Planning and Zoning Commission- Regular Meeting AGENDA

Monday, June 08, 2020 at 5:30 PM
Ketchum City Hall
480 East Avenue North, Ketchum, ID 83340

- 8. ACTION - 4th & Main St Mixed-Use Building Pre-Application Design Review:** Main Street between 4th and 5th Streets (Ketchum Townsite: Block 5: Lots 1, 2, 3, and 4.) The Commission will consider and give direction on a Pre-Application Design Review submitted by Chris Ensign of Solstice Homes Development for a new four-story, 47.5 foot tall, 59,130-square-foot mixed-use building located on four lots on Main Street between 4th and 5th Streets within the Retail core of the Community Core (CC-1). *Continued from March 9, 2020.*

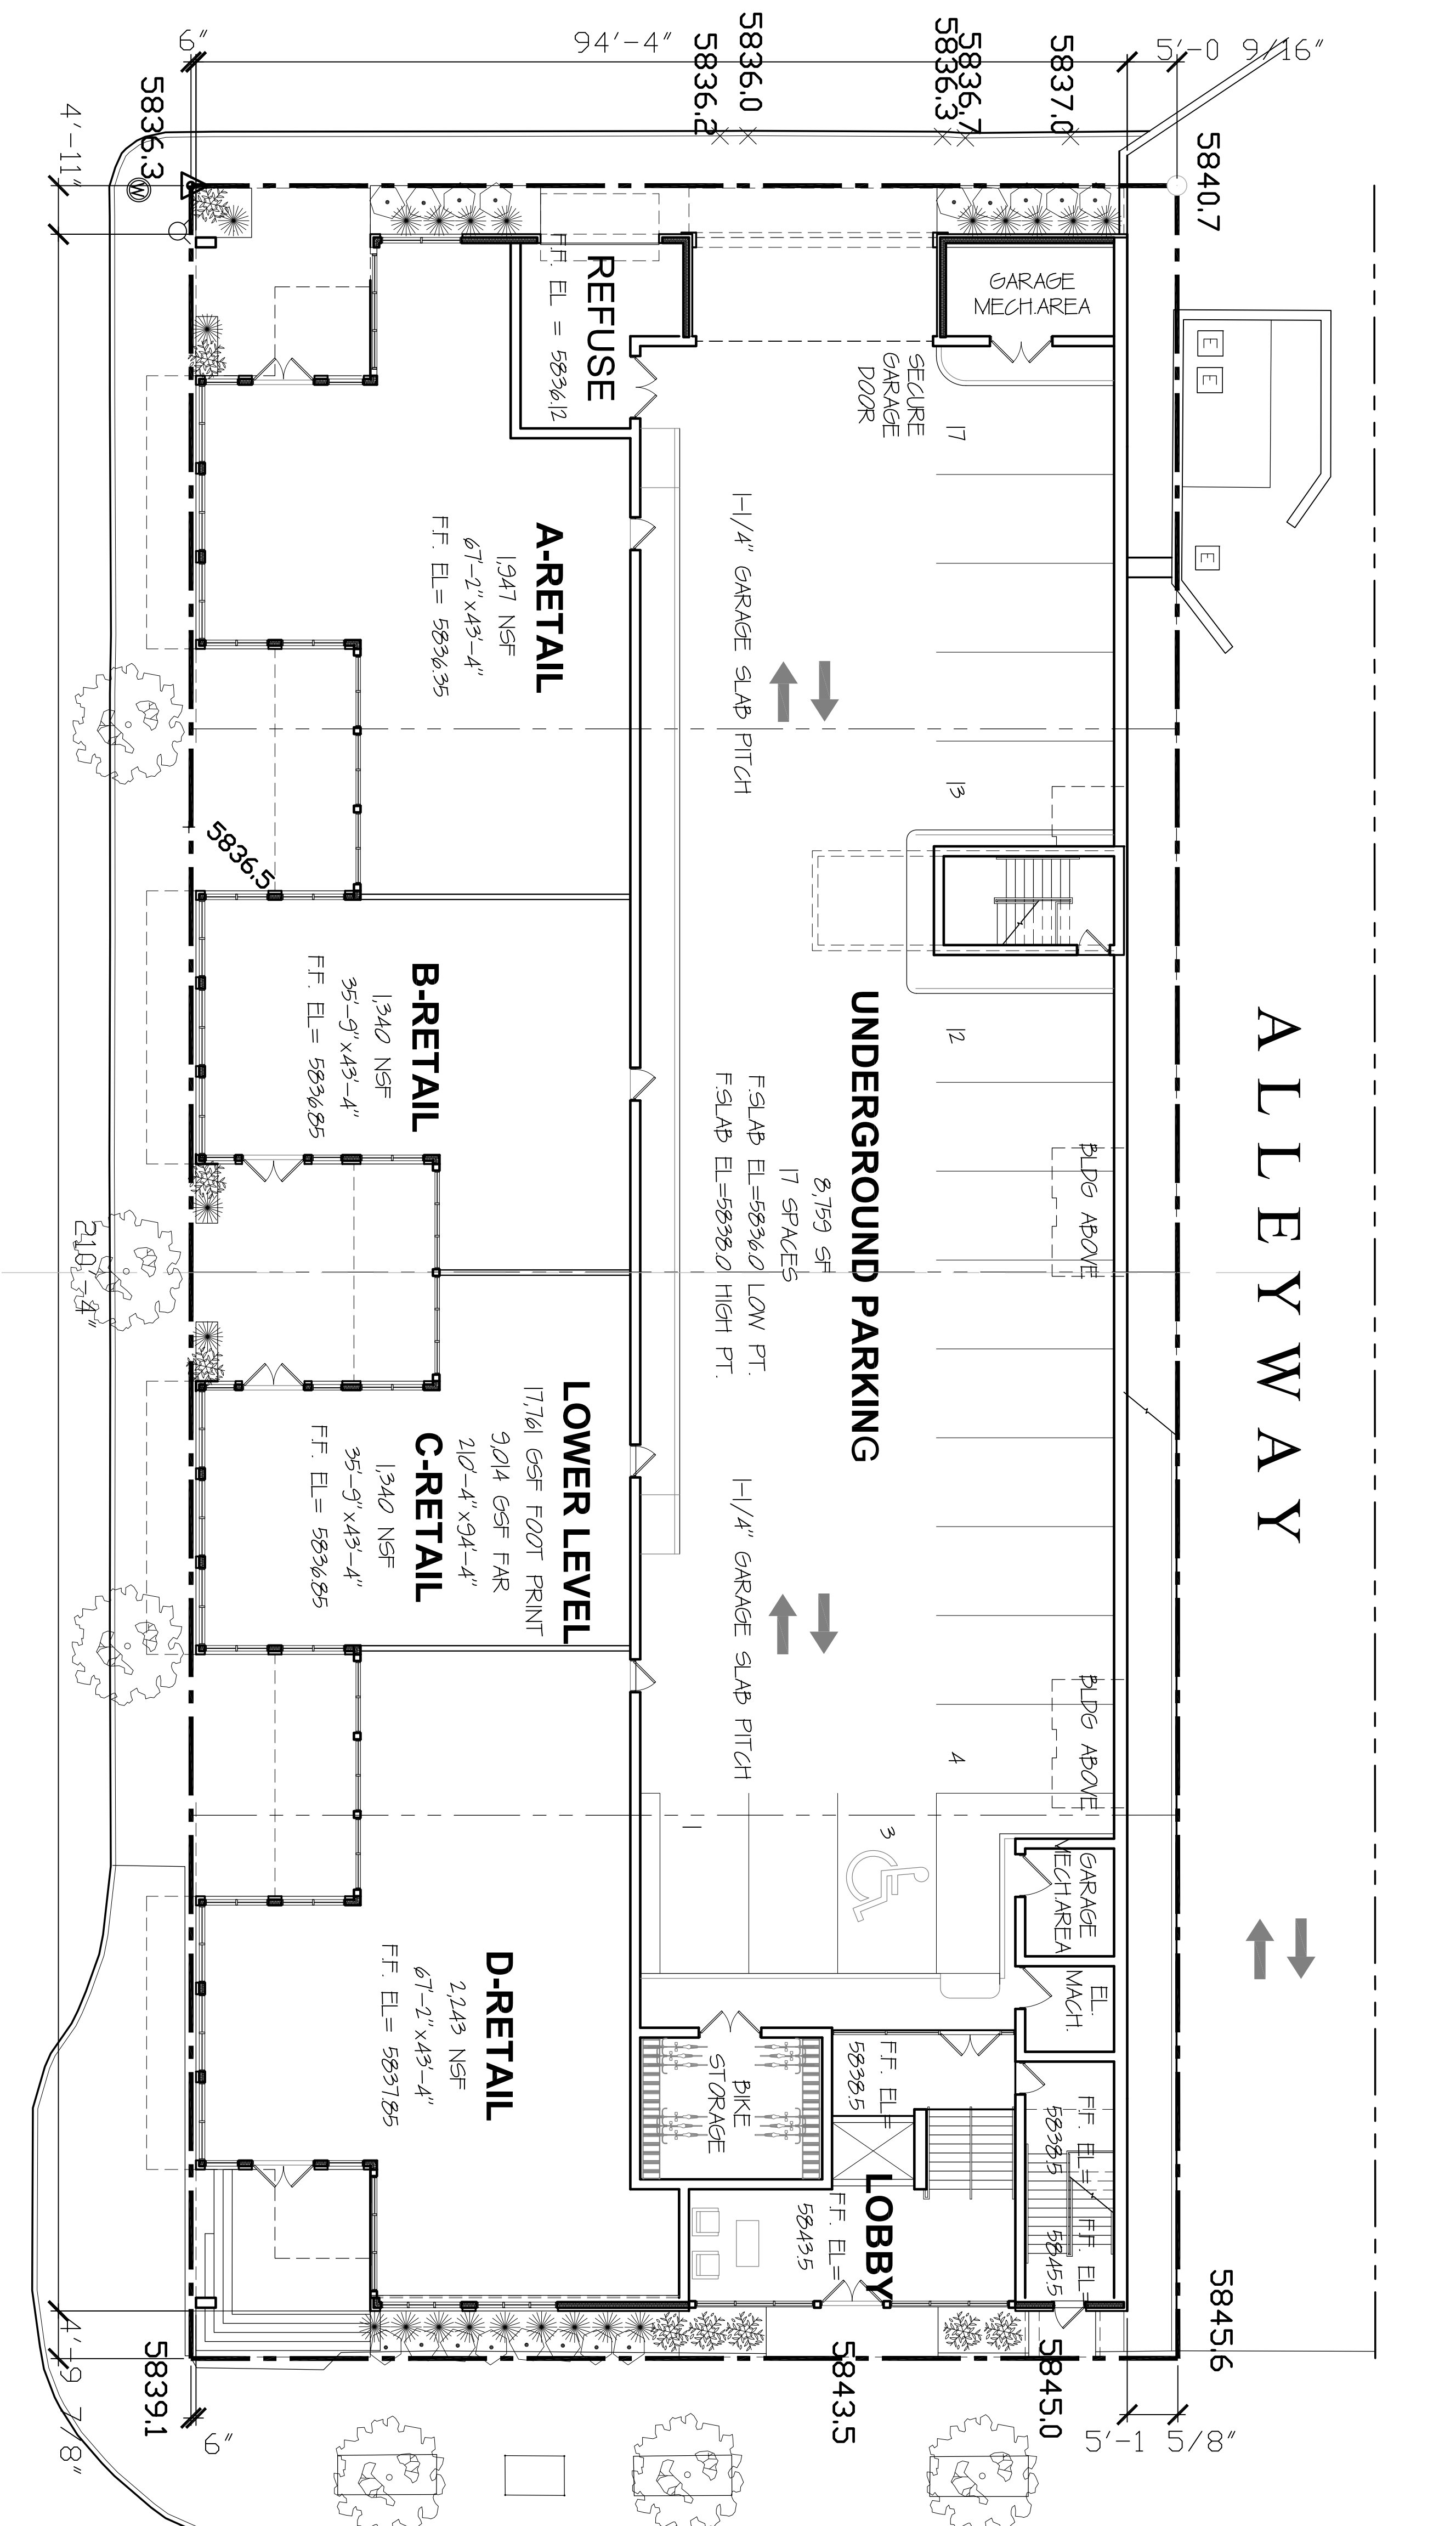
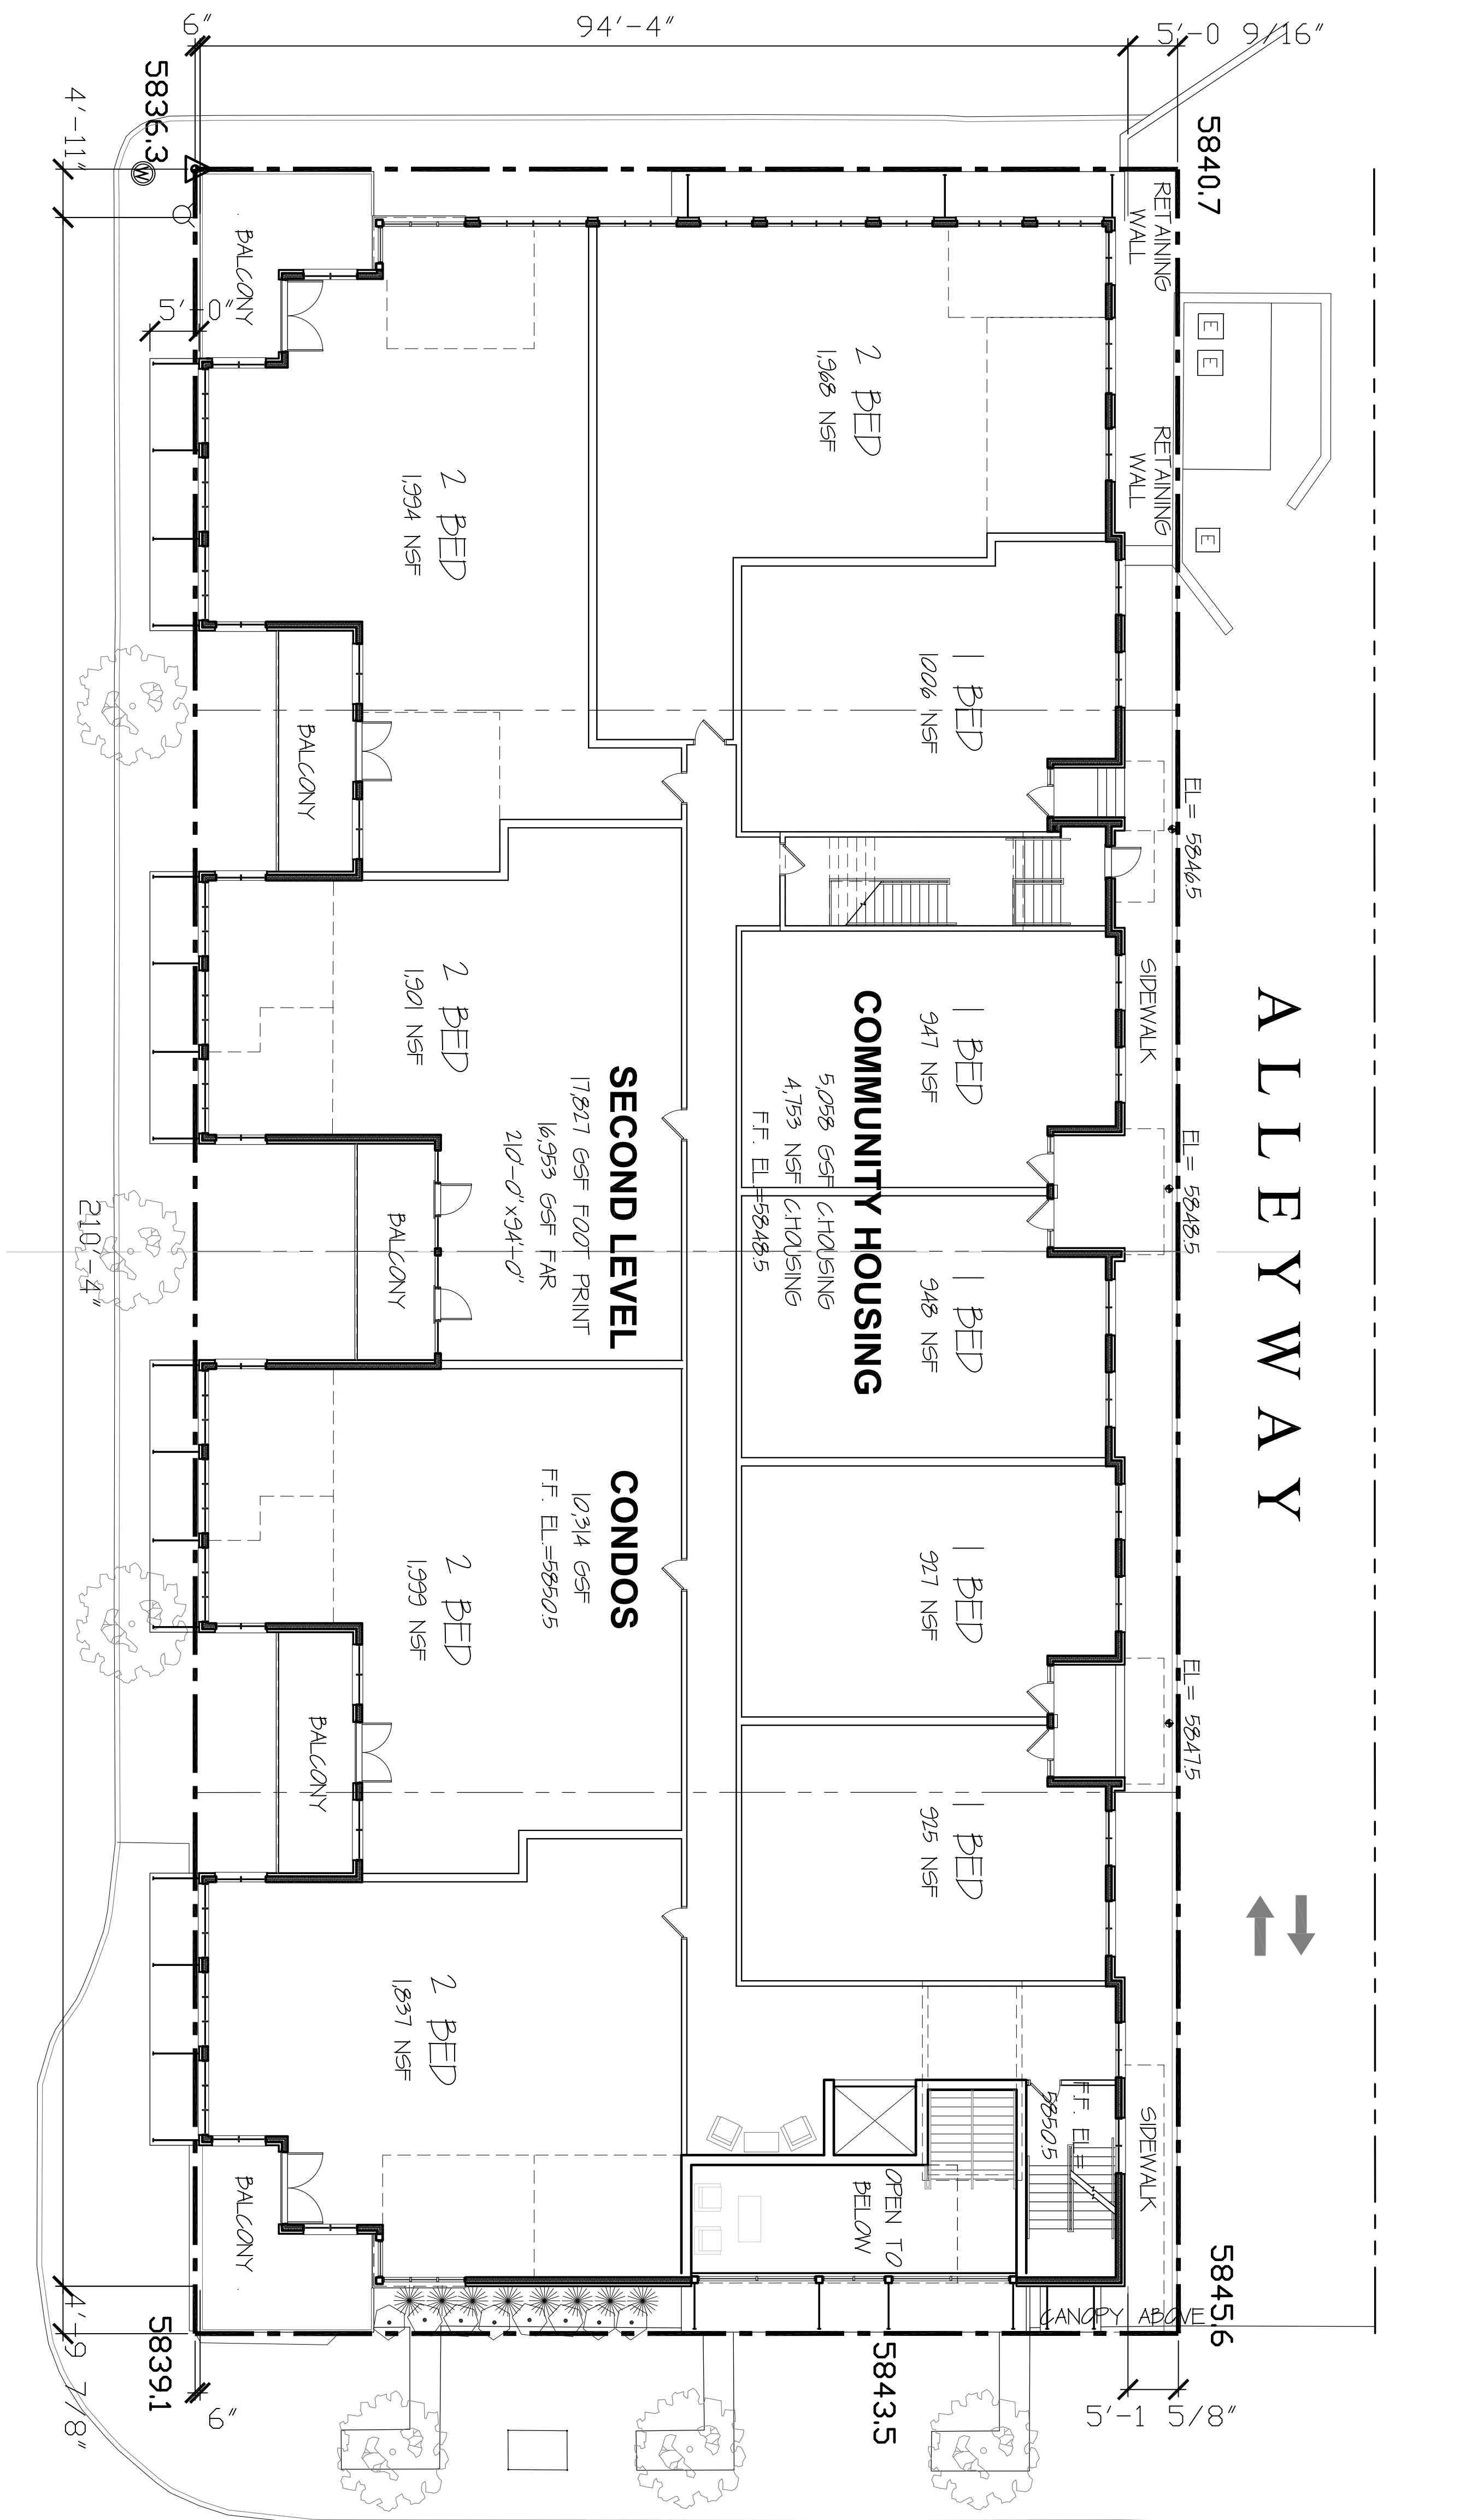
The floor plans on Sheets A1.0, A1.1, A1.2, and A1.3 don’t show the location of window or door openings. The elevations indicate residential units with walls comprised entirely of windows. The building’s outsides don’t match its insides—the exterior of the building doesn’t match the residential use proposed within the building. This discrepancy raises a concern that of the preliminary design drawings unrealistically depict the building’s appearance.
